John Veranth

Comments on Subdivision Roads and Access Standards

January 21, 2024

Road Cross Section:

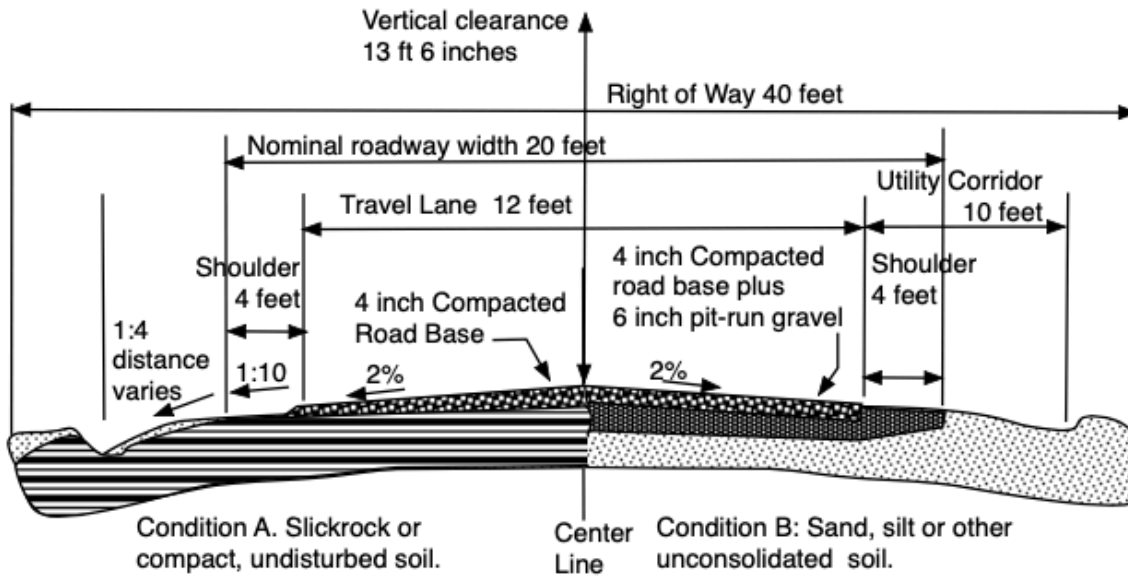
Private subdivision street - minimum all-weather public safety design.

Stormwater notes:

1. Provide culverts where crossing existing natural drainages and roadside ditches.
2. Minor natural drainages may be combined via roadside ditches on uphill side.
3. Minimum culvert diameter 18 inches for drainages handling only on-site rainwater.
4. Minimum culvert diameter 24 inches for drainages handling off-site flows.
5. Minimum compacted fill over culvert 6 inches.
6. Engineered design required for roads crossing side slopes greater than 15 degrees for a distance greater than 50 feet.

Irrigation notes.

1. Irrigation ditch crossings require design approval by the irrigation company.
